**BROWNS FERRY NUCLEAR PLANT (BFN) - UNITS 1, 2, AND 3 -
TECHNICAL SPECIFICATIONS (TS) CHANGES NOS. TS-418 AND TS-431 -
REQUEST FOR EXTENDED POWER UPRATE OPERATION - RESPONSE TO NRC
REQUEST FOR ADDITIONAL INFORMATION OF MARCH 7, 2006, REGARDING
PROBABILISTIC RISK ANALYSES (TAC NOS. MC3812, MC3743, AND
MC3744)**

**RESPONSE TO NRC REQUEST FOR ADDITIONAL INFORMATION OF
MARCH 7, 2006, REGARDING PROBABILISTIC RISK ANALYSES**

Figure Q6-1: Timeline for Cue-Response to a Plant Disturbance

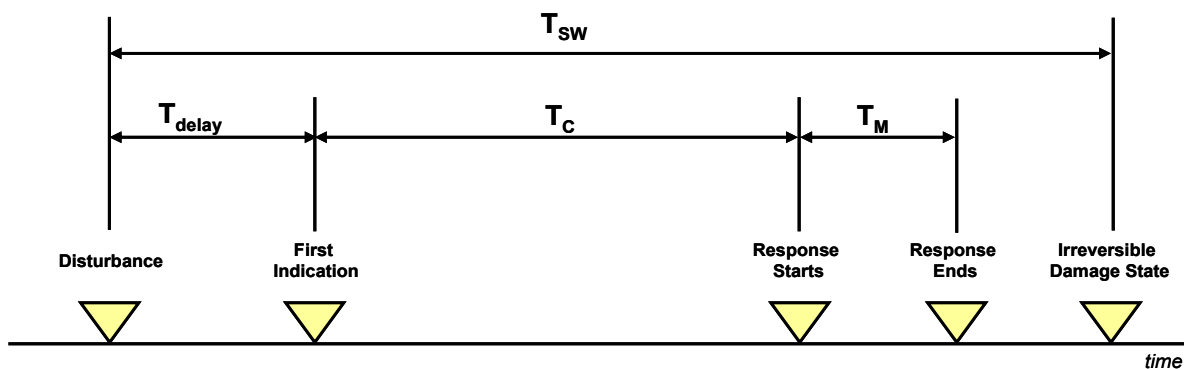
For all three units, for important operator actions (i.e., Fussell-Vesely > .005 or Risk Achievement Worth > 2) that are time critical, justify that these actions can be completed within the time frame from receipt of the cue for the action to the point at which an irreversible plant state leading to core damage is reached under EPU conditions. (For this question, assume "time critical" means the action must be completed within 3 hours of the start of an initiating event or within 1 hour of receipt of the cue.) Provide the basis for the conclusion that the time available is sufficient to complete the action (e.g., information from simulator observations, job performance measures, walk-through, talk-through, etc.).

The adequacy of time to complete actions is a measure of the time to act compared to the time available. Reference 2 provides the methodology and basis for determining times to complete actions. This includes attributes such as time to recognize, diagnose, and accomplish the action. BFN MAAP evaluations are used to define the times available within which the operator must perform the action to avert a change to a failed state (e.g., maintain reactor vessel water level or initiate a safety function).

All three TVA PRAs for BFN take into account the time available and required to recognize and complete human actions as illustrated in Figure Q6-1. The objective is to correctly complete the action before the available time runs out.

- The occurrence of the disturbance requires action. Initially, this is the start of a transient that causes a plant trip, but it could also be the entering of an intermediate state after shutdown (or ATWS).

- The point in time at which the plant transitions to a more degraded state that eliminates the option to accomplish the action. The designation used in the EPRI Calculator for total time between this and the initial disturbance is T_{sw} .

- The time between the beginning of the disturbance and the point at which a cue that something is wrong is presented to the operators is T_{delay} .
- The total time for the operators to complete their cognitive diagnosis of the problem and make the correct decision to accomplish the required manipulations is T_c .

- The time required to execute all the manipulations needed to align and initiate the equipment needed to accomplish the function is T_M .
